# **MOUND FORT MIDDLE SCHOOL STAGE LIGHTING CONTROLS UPGRADE**

**Electrical Addendum #1**

**Issue Date: 12/20/2023**

**ELECTRICAL PLAN  
AUDITORIUM  
AREA**

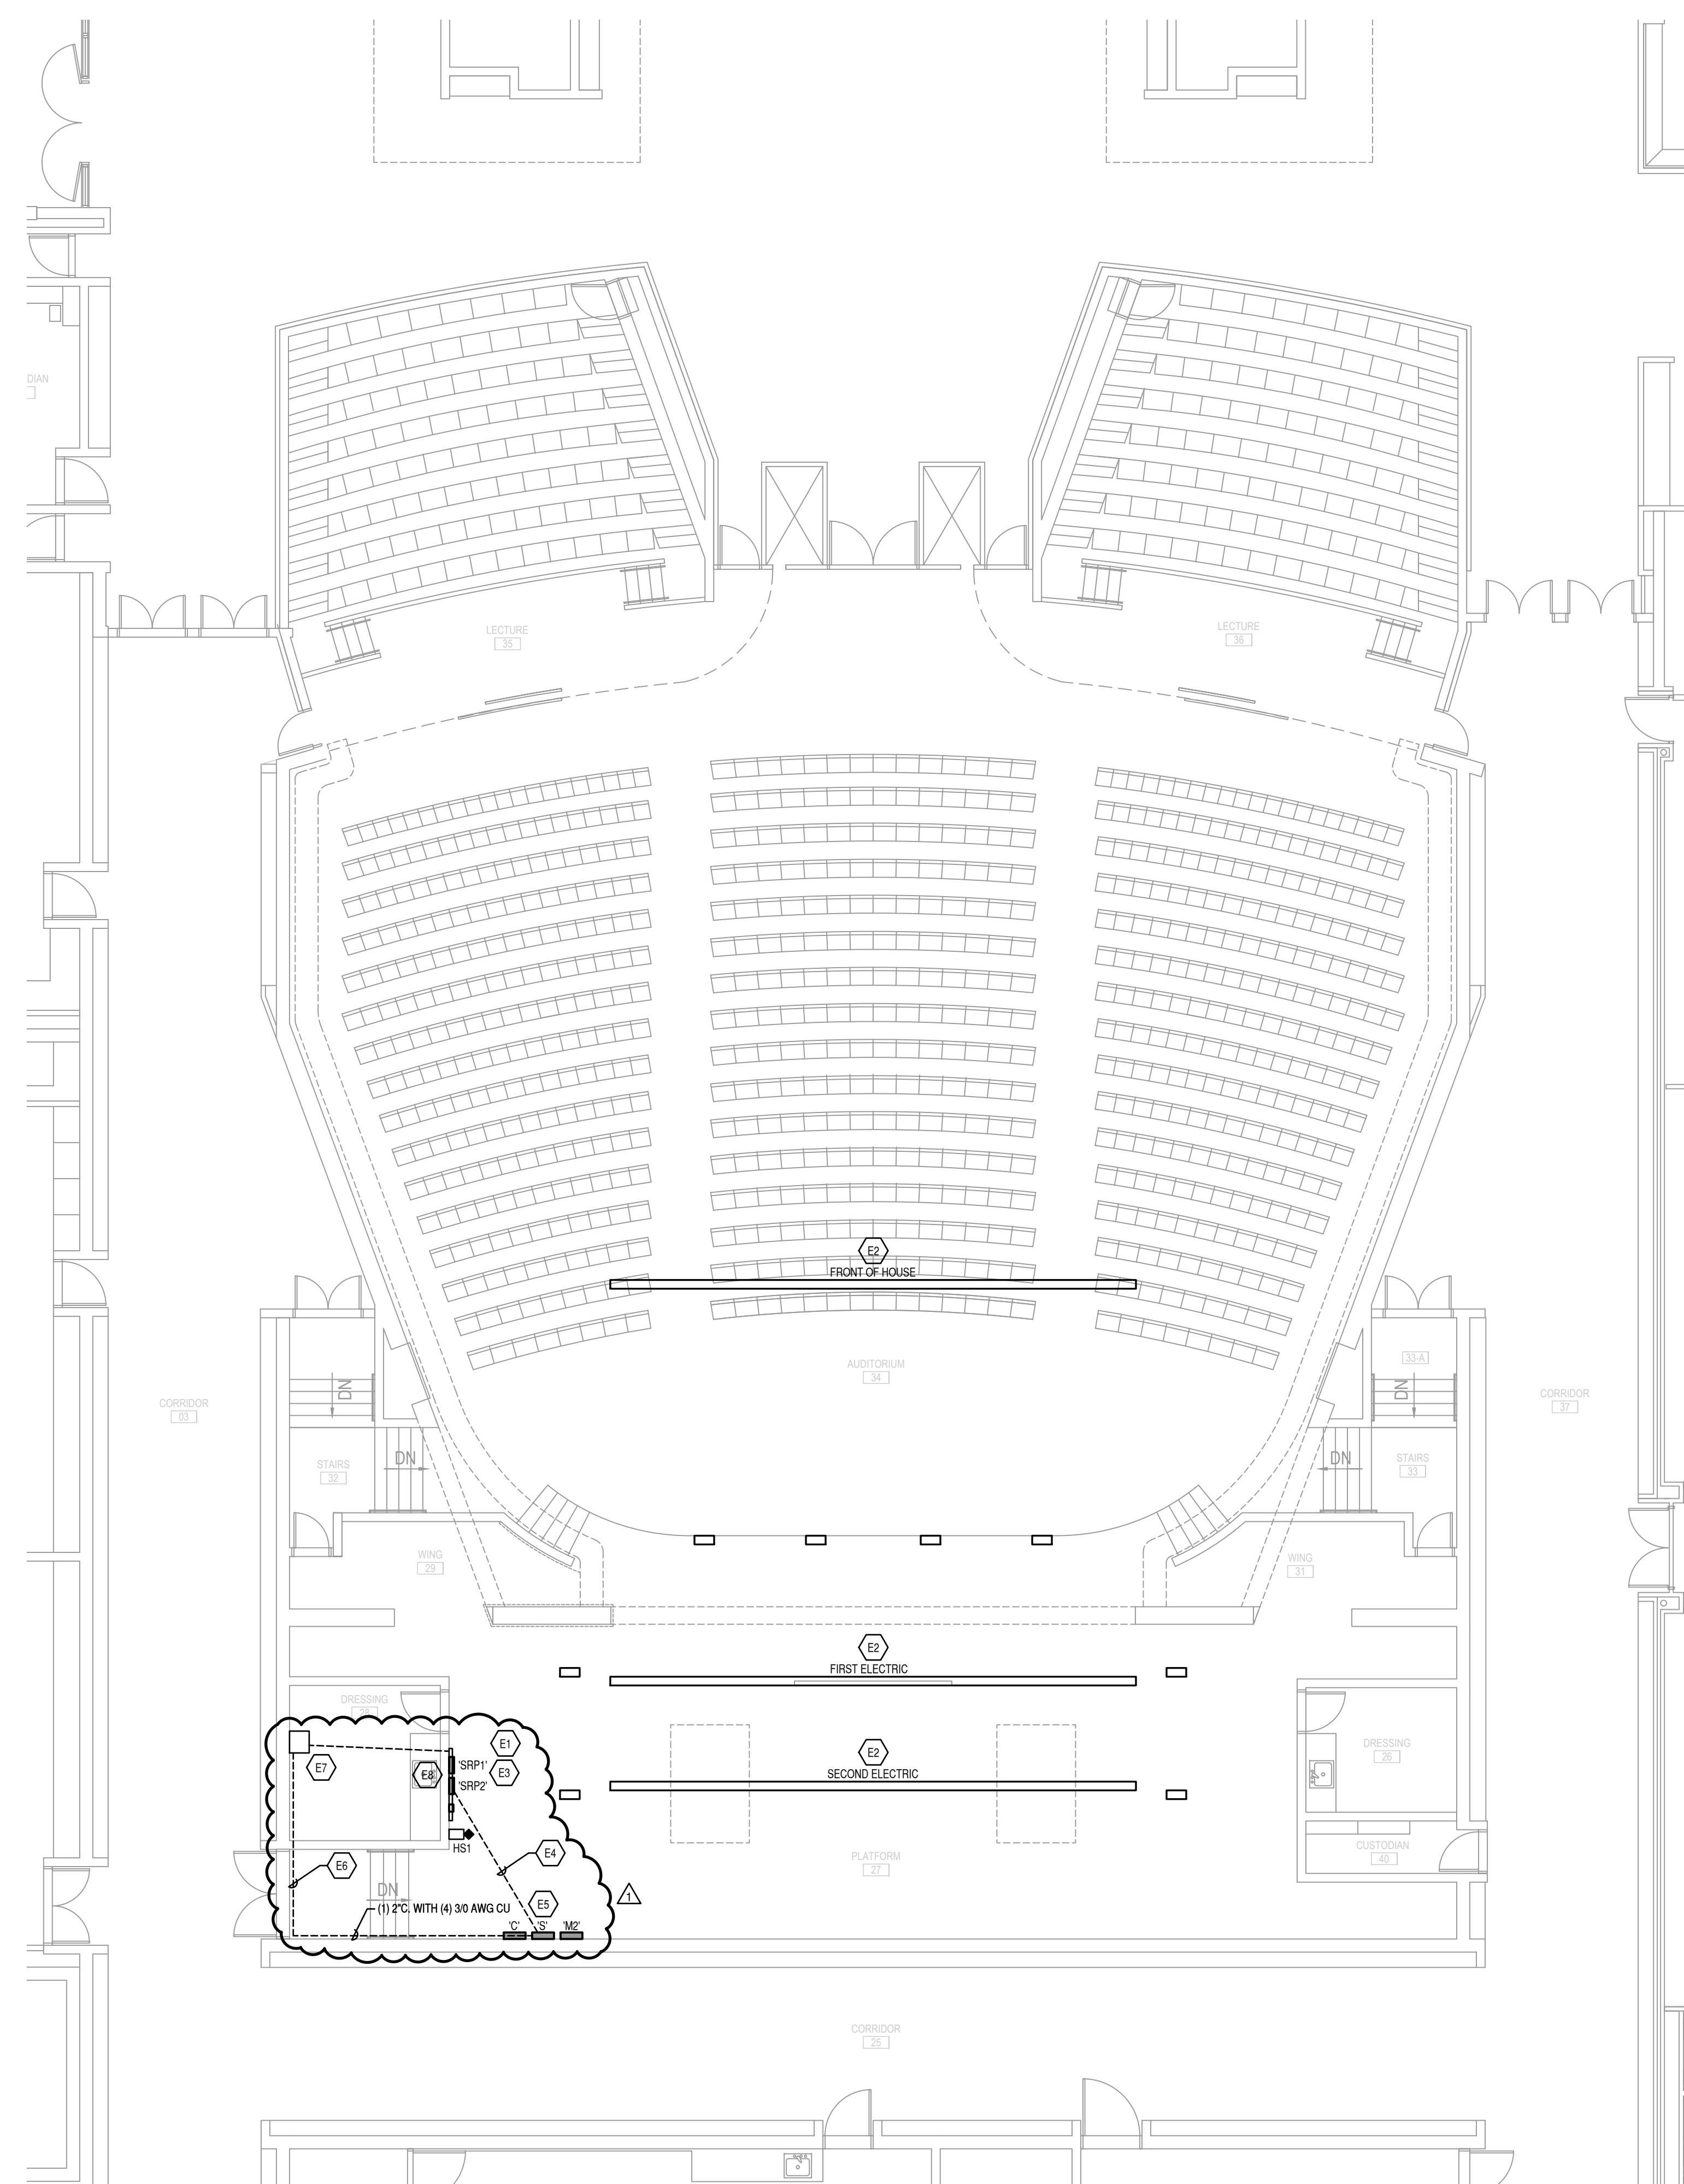
### **SHEET E102**

1. Added the feeder routing and information for the second relay panel.
2. Added the location of the Architectural lighting controls processor.
3. Added sheet keynotes E4 through E9

- E3 PROVIDE NEW THEATRICAL RELAY PANELS.
- E4 EXISTING FEEDERS FOR DIMMER RACK TO BE REUSED, FOR ONE OF THE NEW RELAY PANELS.
- E5 EXISTING 350A BREAKER TO BE REMOVED AND REPLACED WITH (2) 200A BREAKERS, UTILIZED EXISTING SPACE FOR NEW BREAKER.

- E6 PROVIDE NEW CONDUIT AND FEEDER FOR SECOND RELAY PANEL. CONDUITS TO BE RAN FOLLOWING THE PATH OF THE EXISTING CONDUITS FEEDING THE TRANSFORMER ABOVE THE DRESSING ROOM. IT IS POSSIBLE THAT A CRAWL SPACE EXISTS UNDERNEATH THE STAGE THAT THE CONDUIT COULD BE RAN, IF THIS IS THE CASE THE CONDUIT IS TO RAN UNDERNEATH THE STAGE.

- E7 PROVIDE A NEW PULL BOX FOR FEEDER TO RELAY PANEL, SIZE PER CODE REQUIREMENTS.
- E8 IT APPEARS THAT THE EXISTING BRANCH CIRCUITS ENTER THE DIMMER PANEL FROM BELOW. PROVIDE A GUTTER BELOW THE RELAY PANELS TO EXTEND THE BRANCH CIRCUITS.

- E9 PROVIDE ARCHITECTURAL LIGHTING CONTROLS PROCESSOR FOR LIGHTING SYSTEM. PROVIDE A 20A CIRCUIT FROM PANEL 'S' TO THE PROCESSOR.
